WATERMARK AT AKERS SITE DEVELOPMENT PLAN

TRACT DD, HANNAH RIDGE AT FEATHERGRASS FILING NO. 1, AS AMENDED

**COVER SHEET
SHEET 1 OF 11**

SITE PLAN
 SHEET 2 OF 11

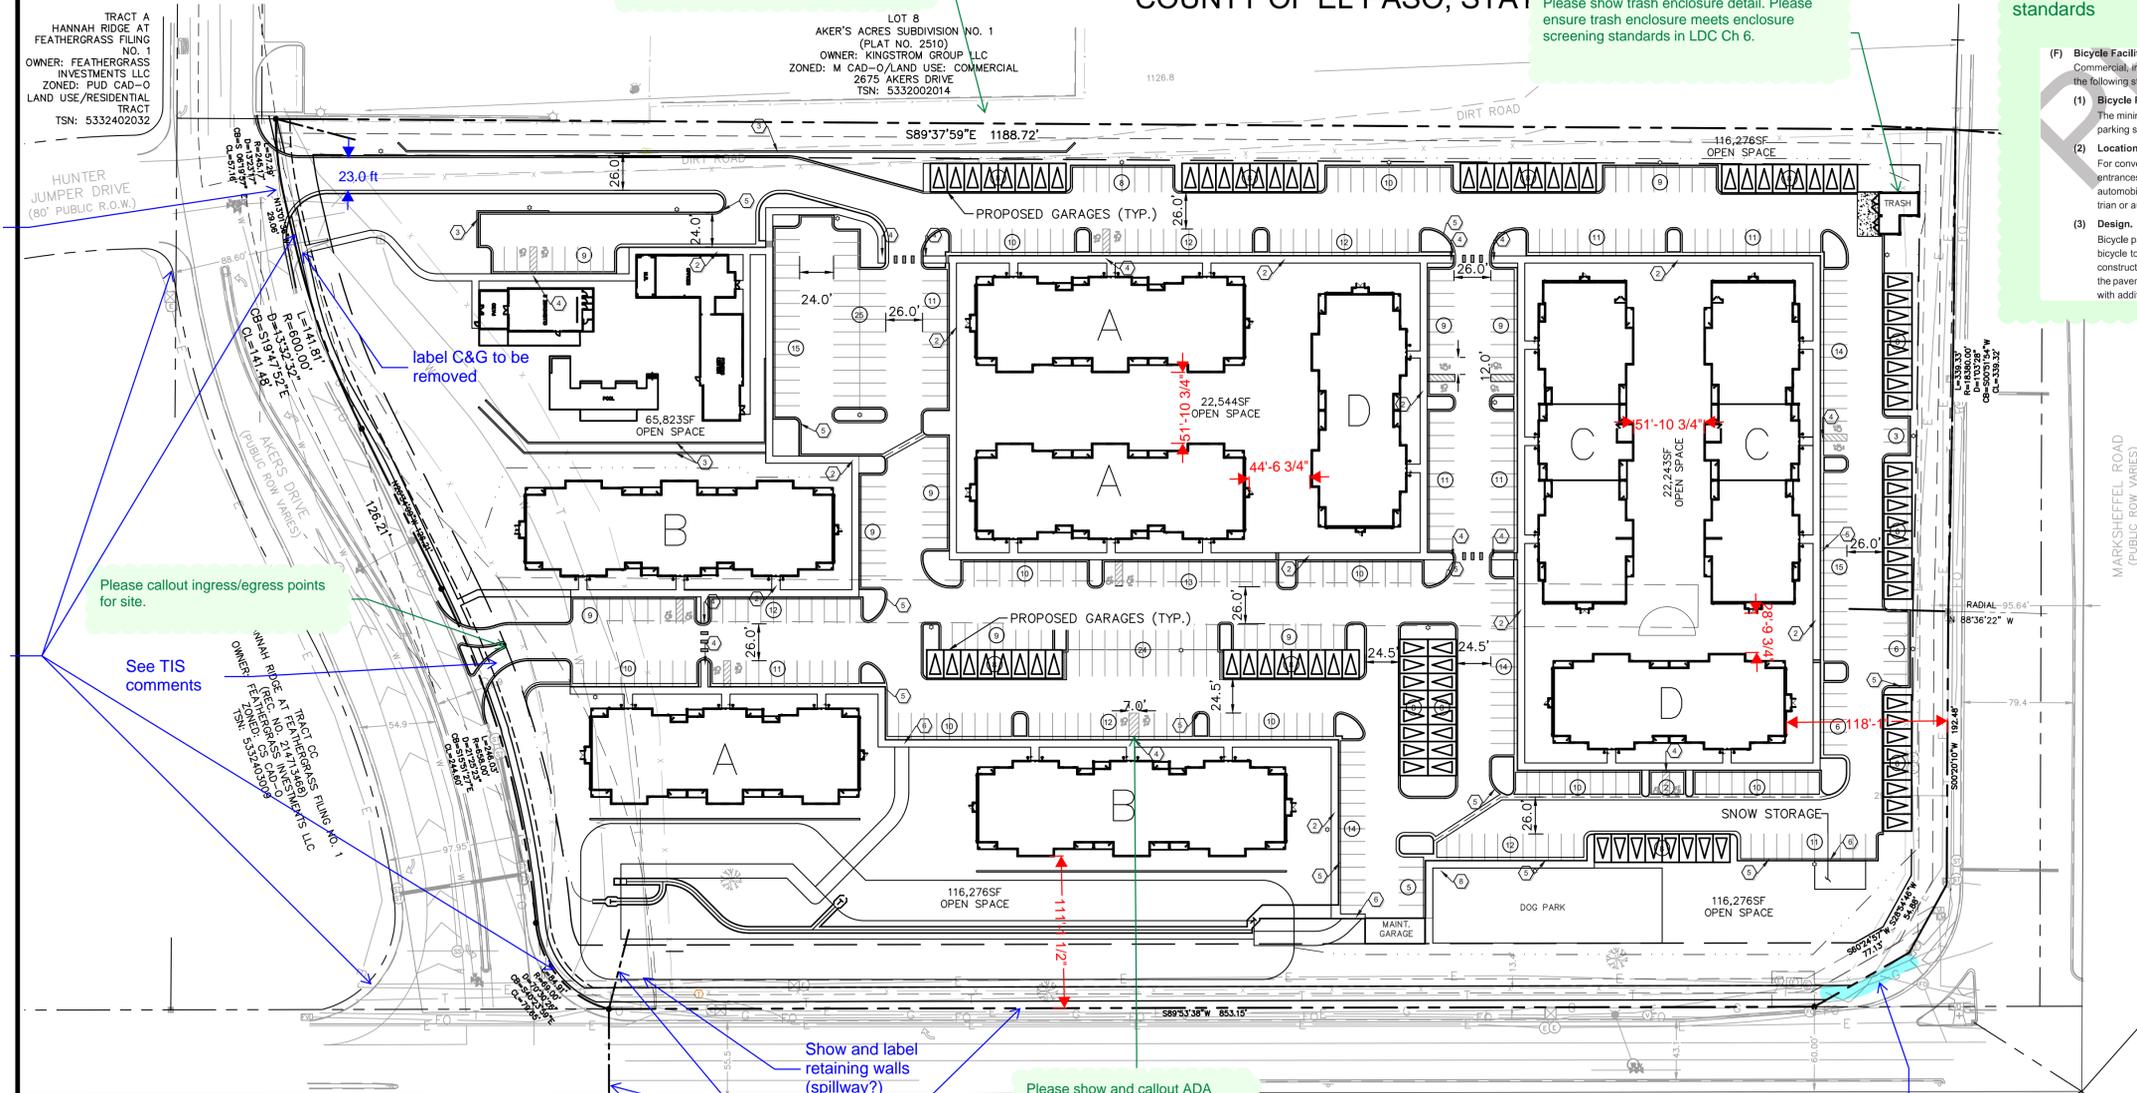
Please add bicycle parking. Per Chapter 6 LDC parking standards

Dimensions of buildings, pool/community areas, dog park area and open spaces?
 As well as additional information for dog park such as access points?

Please show trash enclosure detail. Please ensure trash enclosure meets enclosure screening standards in LDC Ch 6.

label crossspan reconstruction

label C&G to be removed

Show pedestrian ramps

Please note that the requirement for 2 bedroom units is 1.7 spaces per unit. This means 266 spaces are required for the U2 / 2bedroom units, not 273. total parking spaces required is 494. An additional 2%, or 10 spaces, must be ADA.

Please callout sidewalk widths on plan, or if all sidewalks are 5' wide, then please note same.

Please show and callout ADA Route throughout site, from parking areas to buildings.

Show and label retaining walls (spillway?)

Show ROW dedication

Show sidewalk connecting

UTILITY PLAN
SHEET 3 OF 11

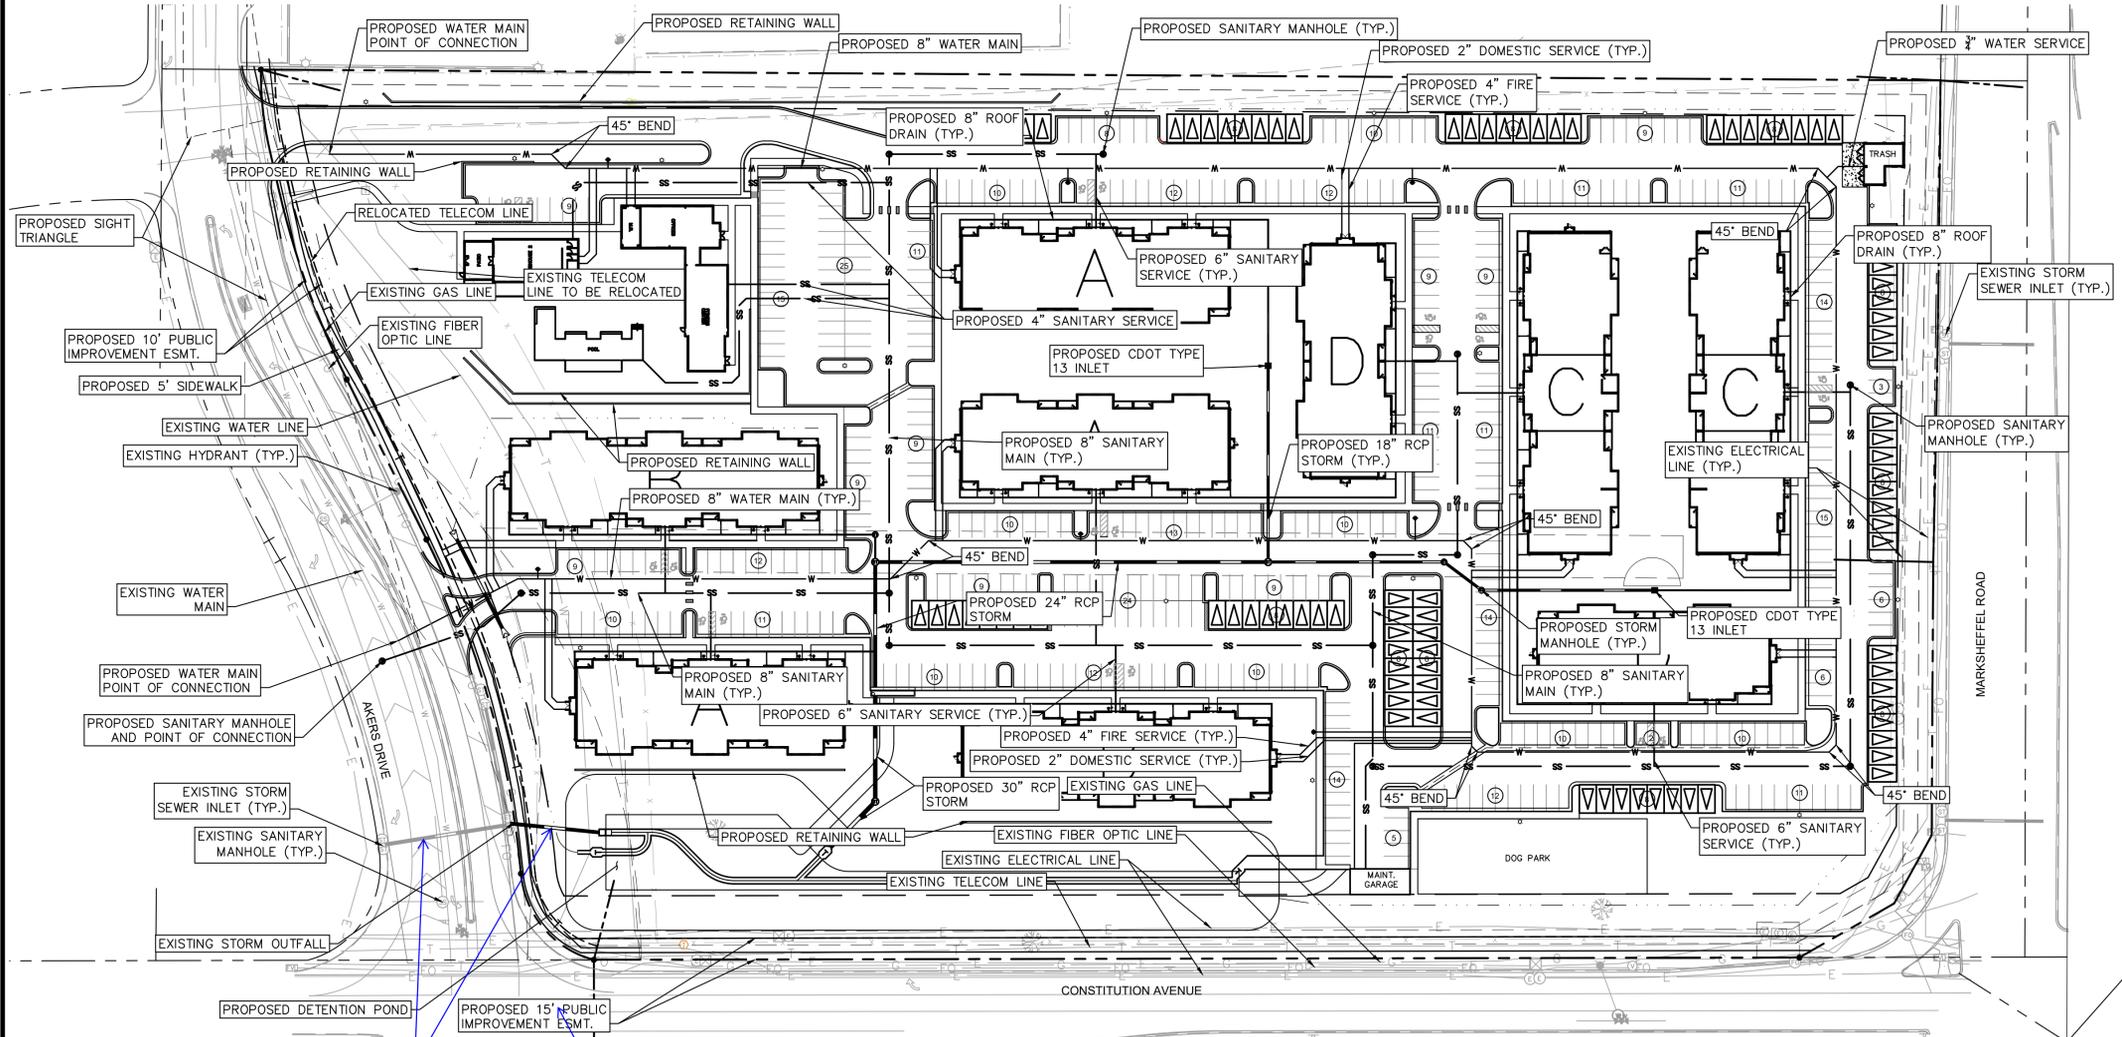
Label pipe sizes
20' ROW dedication?

GRADING PLAN
SHEET 4 OF 11

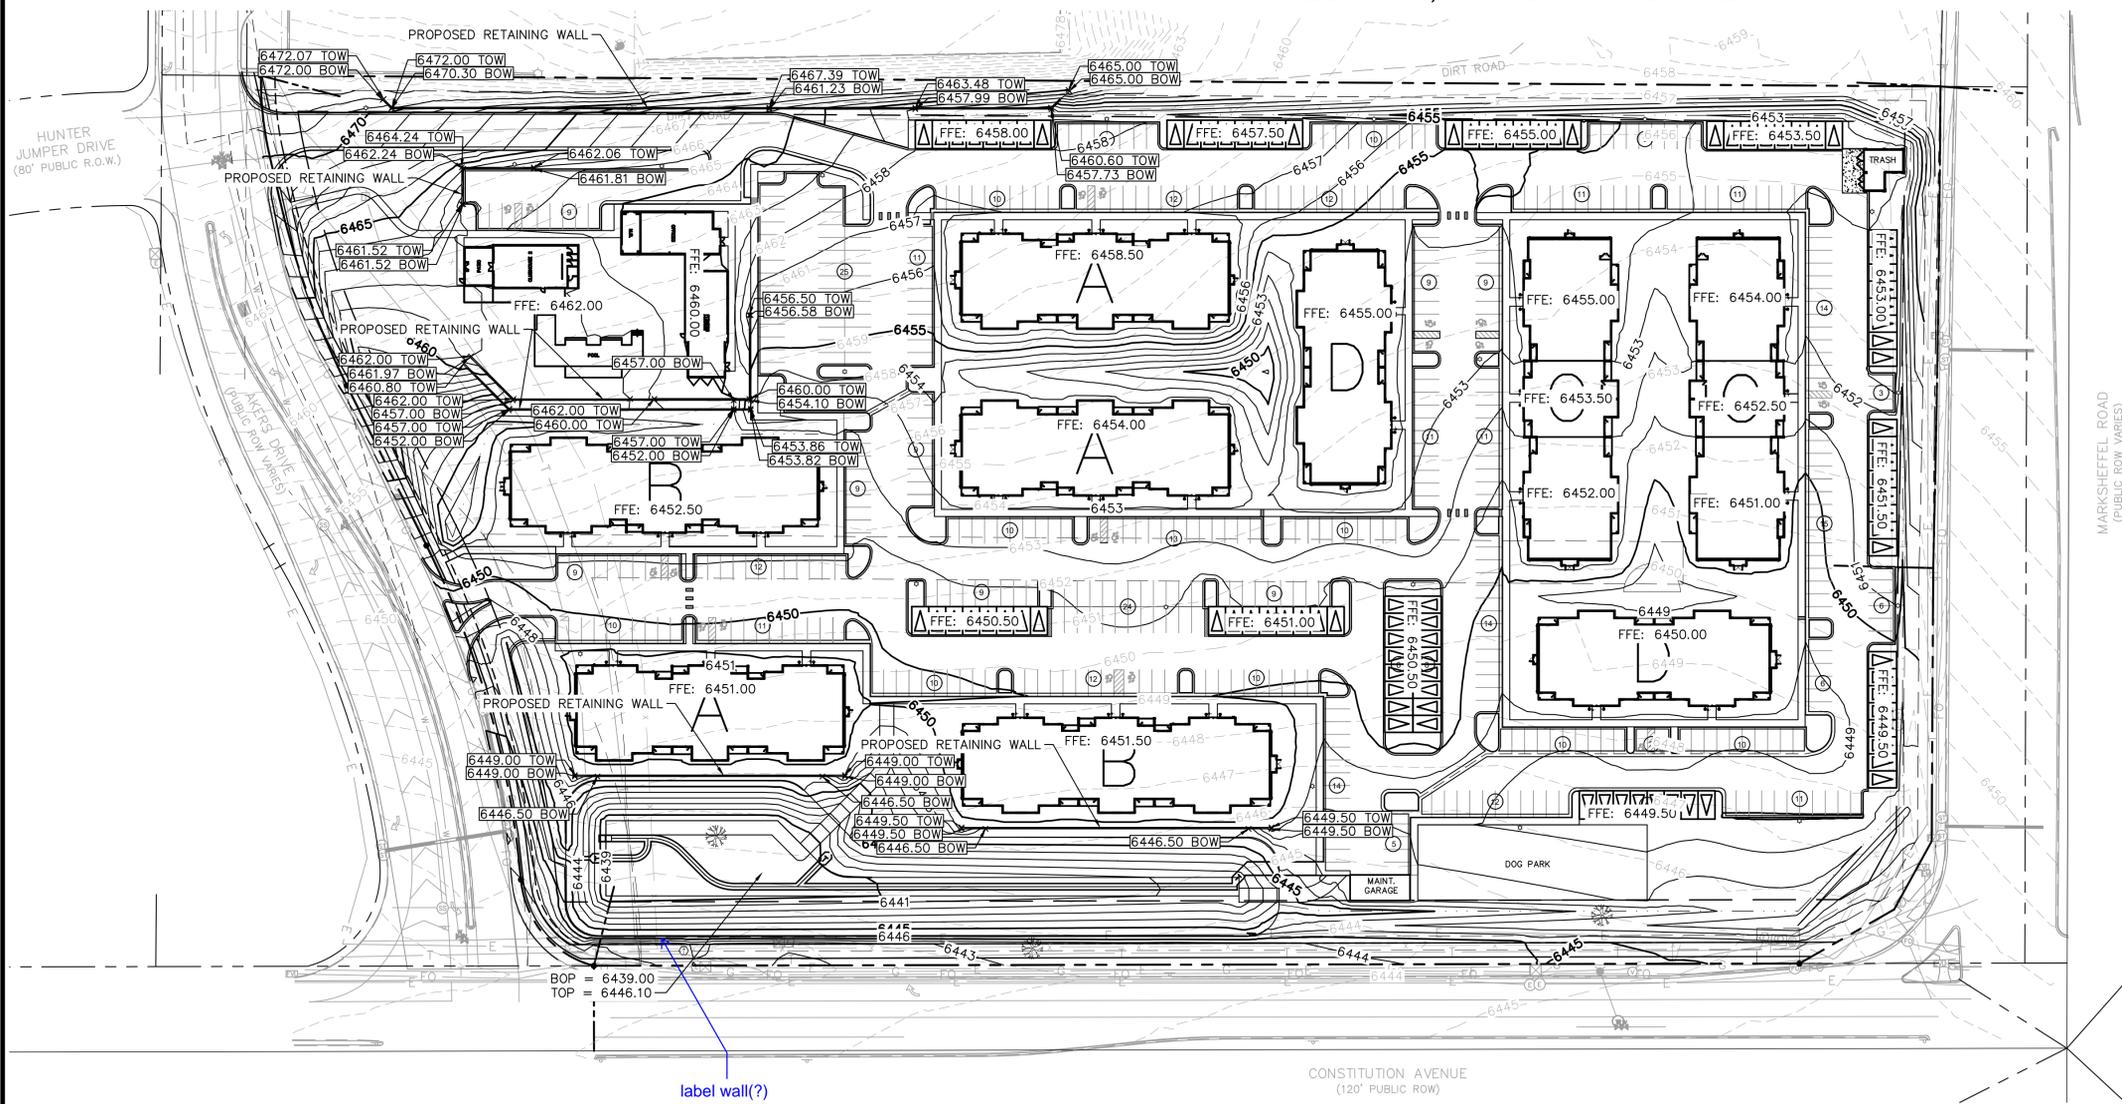
label wall(?)
